ORDINANCE NO. _____

AN ORDINANCE to amend and reordain the Master Plan of the City of Alexandria, Virginia, by adopting and incorporating therein the amendment heretofore approved by city council to the Landmark/Van Dorn chapter of such master plan as Master Plan Amendment No. 2020-00009 and no other amendments, and to repeal all provisions of the said master plan as may be inconsistent with such amendment.

- a. Updates to text as provided below. *Deleted text is shown with a ~~strikethrough~~. Revised or additional text is underlined. The page numbers reference Chapter 10 of the Landmark/Van Dorn Corridor Plan which restarts its numbering sequence on page 1.*

Figure 2: Framework Plan and Complete Street Typology

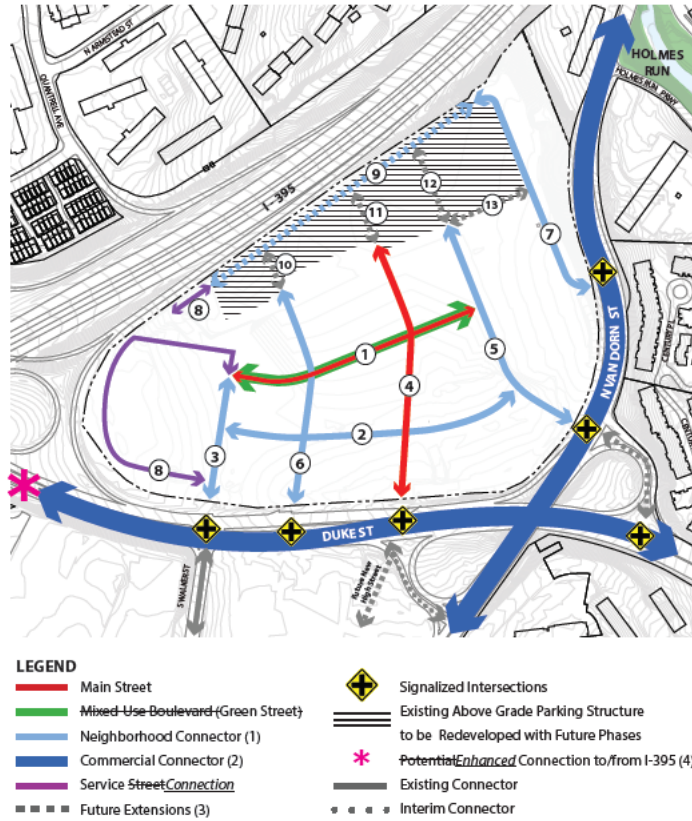
- The Plan recommends coordinating with the Virginia Department of Transportation (VDOT) to explore the opportunity for ~~a ramp an enhanced~~ connection with I-395 (Figure 2). In addition, the Plan recommends a potential pedestrian/bicycle bridge connection over I-395 to improve connectivity and access to the Landmark neighborhood as generally depicted in Figure 10.

- **10.1.13** Pursue Virginia Department of Transportation (VDOT) and all applicable agency approvals for ~~a ramp~~ an enhanced connection with I-395 as generally depicted in Figure 2 as part of a joint effort between the City and the property owner.

- Notes:
1. Framework Street 1 to be designed and constructed as a Neighborhood Connector but used in the interim as a Service Street.
 2. Improvements limited to property frontage.
 3. Future street extensions in the event that the above grade parking structure is redeveloped.
 4. Location of a potential enhanced connection is for illustrative purposes only. Final location will be in coordination with VDOT and the City.

Figure 9: Transit Hub

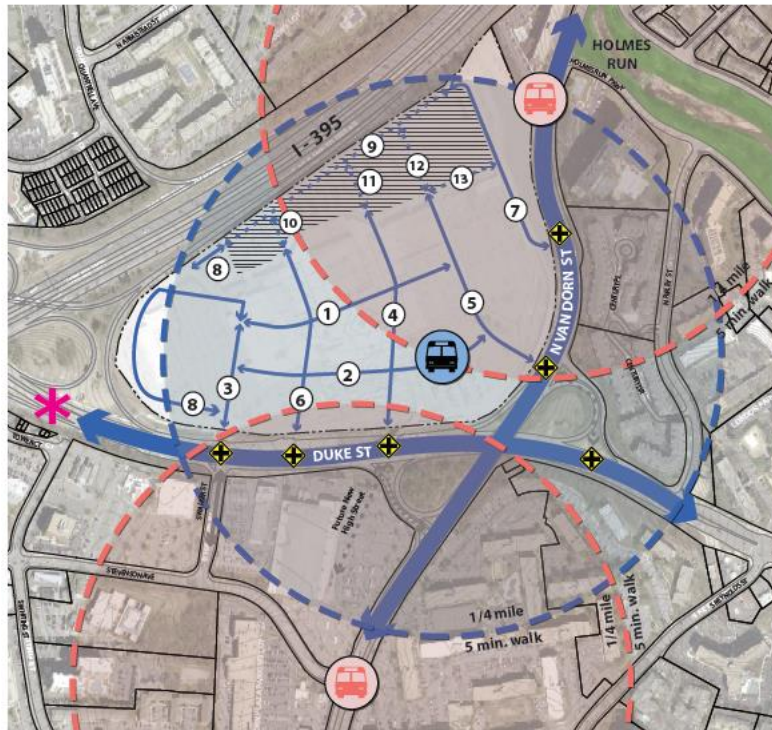
- 5. BRT will be provided on-street parallel to the curb on Framework Street ~~D 2~~ as generally depicted in Figure 9. Bus shelters will be provided in the Amenity Zone.

1. The proposed transit hub is for illustrative proposes only. Final location and coordination will be determined during the development review process.
2. Location of a potential enhanced connection is for illustrative proposes only. Final location will be in coordination with VDOT and the City.

Figure 10: Pedestrian and Bicycle Facilities

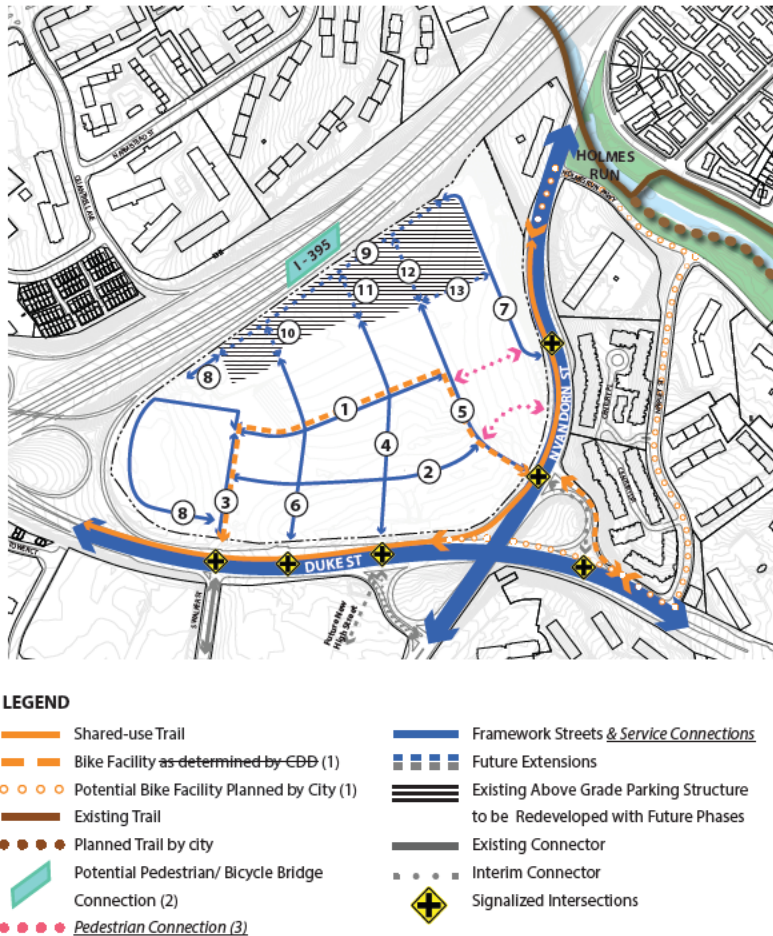
- **10.1.8** Provide dedicated bicycle facilities on N. Van Dorn Street, Duke Street and Framework Streets ~~D, E and F~~ 1, 3, and 5 as generally depicted in Figure 10. Final configuration of bicycle facilities in these locations will be determined as part of the Coordinated Development District (CDD) approval(s). Potential bicycle facilities and accommodations for the remaining Framework Streets will be determined as part of the CDD approval(s) and Infrastructure Plan.

1. Bicycle facilities may be a shared-use, enhanced bicycle corridor (dedicated lanes) or shared roadway (sharrow), consistent with the Transportation Master Plan.
2. Location of a potential connection is for illustrative proposes only. Final location will be in coordination with VDOT and the City.
3. Location of pedestrian connection from Road 5 to N. Van Dorn Street will be determined in the development review process.

Figure 12: Open Space

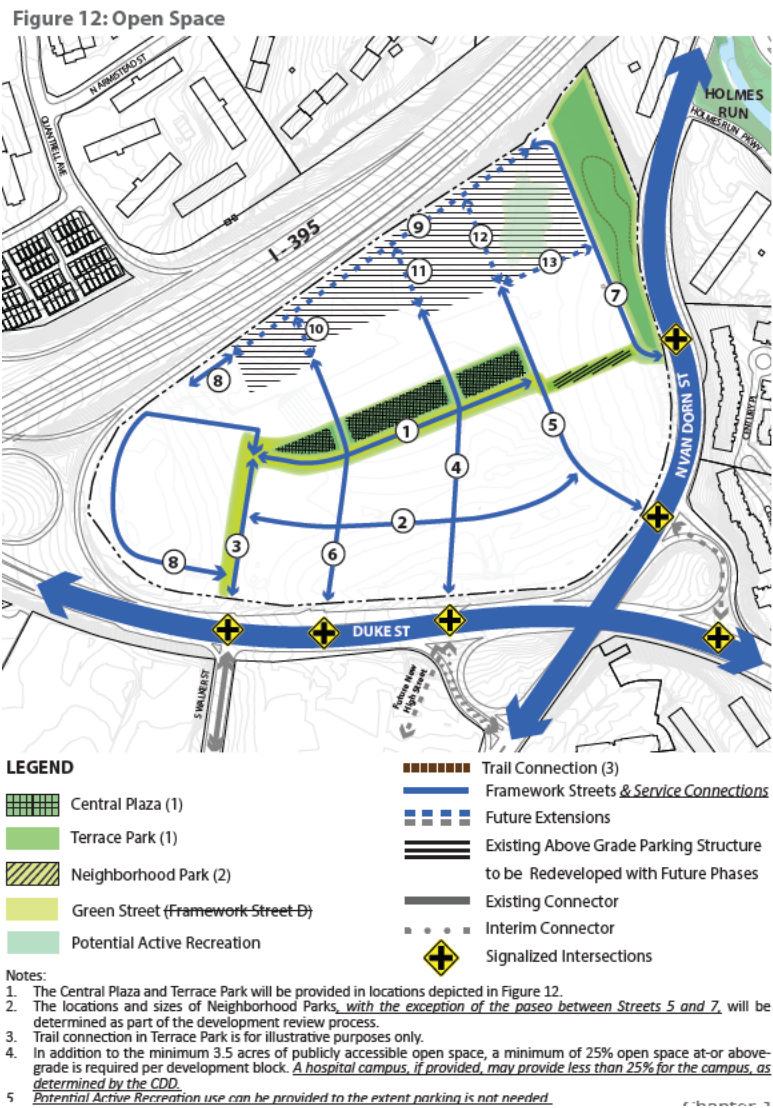
- At least 3.5 acres of publicly accessible at-grade open space will be provided in the approximate locations shown in Figure 12, with each space designed to be physically and visually connected by the neighborhood's green street, Framework Street ~~D 1~~. Each publicly accessible open space will be made accessible and usable to the public through dedication or provision of a perpetual public easement to the City. The minimum 3.5 acres of publicly accessible at-grade open space will consist of the following:

Figure 13: Land Use

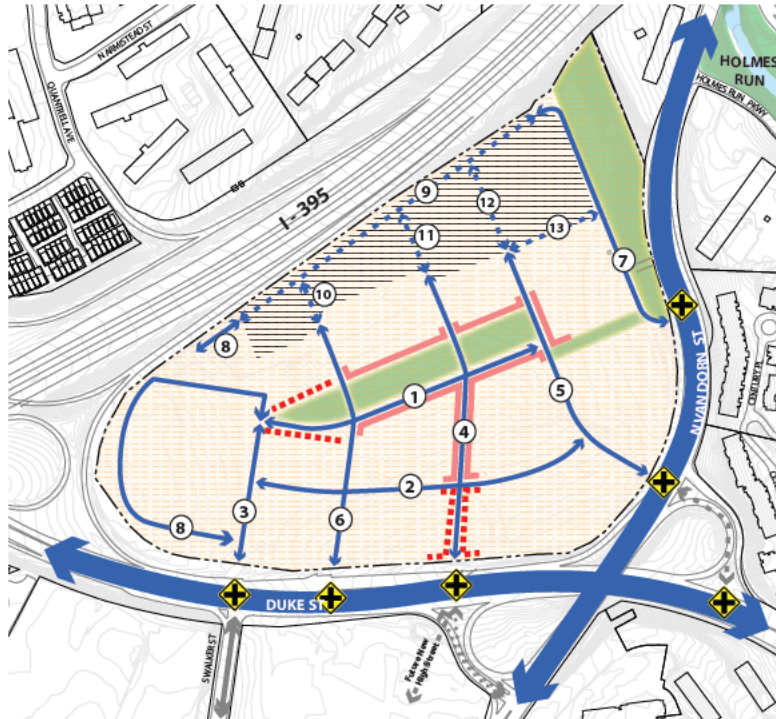
- **10.2.7** Of the ~~25%~~ open space per development block, publicly accessible ground level open space should be prioritized.
- **10.3.2** Provide required and preferred ground floor active/retail uses in the locations as generally depicted in Figure 13. Permitted uses in these locations must activate the adjacent street and/or open space. The specific uses permitted as retail will be established as part of the CDD approval(s).

- **10.3.3** In the required and preferred ground floor active/retail locations depicted in Figure 13, provide ground floor minimum ~~floor-to-ceiling~~ height of ~~17.5~~ 15 feet and minimum depth of 30 feet and building design that engages the public realm through use of transparent windows and building articulation.

Figure 16: Building Streetwall, Gateway and Placemaking Opportunities

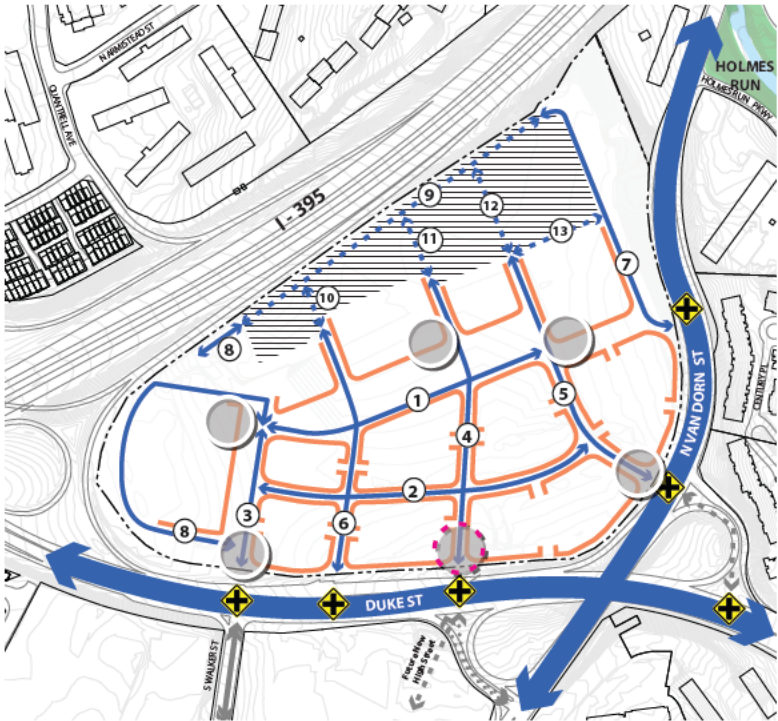
- 35 • Neighborhood-wide design standards for the public realm and buildings, including
36 elements such as lighting, signage/wayfinding, public art, setbacks, building massing,
37 articulation and other comparable features will be determined prior to submittal of the
38 first development special use permit. Design standards will be provided for buildings
39 taller than 100 feet to address sun and shade patterns across the neighborhood, and
40 emphasis will be given to the gateway at Framework Street ~~B4~~ and Duke Street to
41 visually denote this entrance to the retail core of the neighborhood (Figure 16).
42
43
44
45
46
47
48

- **10.5.6** Prepare general neighborhood-wide design standards for the public realm and buildings, including elements such as lighting, signage/wayfinding, public art, setbacks, building massing, articulation and other comparable features, that implement the vision of the Landmark neighborhood prior to submittal of the first development special use permit. Emphasize features at Framework Street ~~B4~~ and Duke Street as shown in Figure 16 to denote this entry to the retail core of the neighborhood.

- The Enhanced Retail Entrance will include elements such as signage, public art, lighting, architectural massing, setbacks, and other comparable features as determined during the development review process.
- Streetwalls are shown for illustrative purposes only and will be determined during the development review process.
